SERVICE**BULLETIN****SB #:** F115**BRANDS:****DATE:** JULY 2016**TO:** ALL AUTHORIZED FERRIS DEALERS**SUBJECT:** POSSIBLE MISSING GEARBOX VENT ON IS2600Z UNITS**MODELS:** SEE LIST BELOW

DESCRIPTION

Figure 1. Inspecting the Gearbox

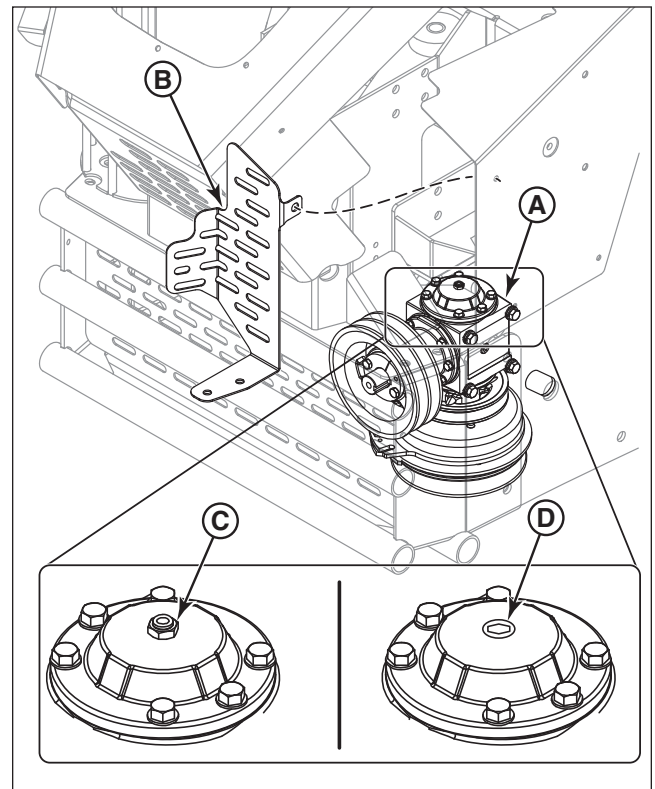
3. Observe the top of the gearbox (**A, Figure 1**). If the unit was shipped outside of the United States it is equipped with an additional flywheel guard (**B**). The top of the gearbox can be viewed by looking through the slots of the flywheel guard or if necessary the flywheel guard can be temporarily removed.

- If the gearbox is equipped with the raised hex vent (**C**) the gearbox vent **is installed**, continue with step # 5. **The correction procedure is not necessary.**

- If the gearbox is equipped with a round internal hex set screw (**D**) the gearbox vent **is not installed**, continue with step # 4.
4. Inspect the gearbox's lower seal (**A, Figure 2**) for oil leakage. From beneath the machine the bottom gearbox shaft seal can be viewed. If the gearbox is leaking oil there will be oil and excessive dust, grass, and debris built up.

1. If the unit does not have a vent installed and does not show signs of oil leakage order and install Kit # 5600964 - “Kit, Gearbox Vent, IS2600Z”.

If the unit does not have a vent installed and shows signs of oil leakage, order and install Kit # 5900965 - “Kit, Gearbox Replacement, IS2600Z”.
